Transmittal: Response to December 4, 2008 Comments
Energy Queen Mine, M037043, San Juan County

**ENERGY QUEEN MINE
APPLICATION FOR MINERAL
MINE PLAN AMENDMENT
PERMIT No. M/037/043
SAN JUAN COUNTY, UTAH**

**APPLICATION FOR MINERAL
MINE PLAN AMENDMENT
REVISED JANUARY 2009**

FIGURE SWPPP-3
ENERGY QUEEN MINE
SURFACE DRAINAGE MAP

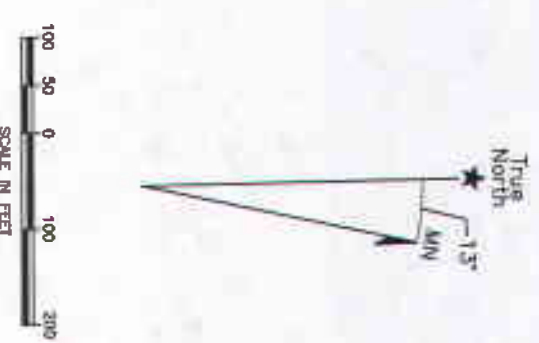
Response to Comment 1, Figure SWWWP-3 (tm): The referenced figure (Surface Drainage Map) has been updated to include more detail and is submitted herein. The primary storm water discharge point for the mine site is located in the south-central portion of the site (Collection Point #1). There is also an emergency overflow at the Sedimentation Pond (Collection Point #3) and an upstream sampling point (Collection Point #2). The majority of the storm water within the treatment area in Section 5 is routed to the existing and future lined ponds, although some off-site sheet flow occurs over revegetated perimeter areas.

The treated water discharge point is located at the ephemeral drainage immediately west of the northwest corner of the Untreated Water Pond. A ripped emergency overflow from the same pond is located just downstream from the treated water discharge point. Samples of treated water will be collected in accordance with the requirements of the approved surface water discharge permit.
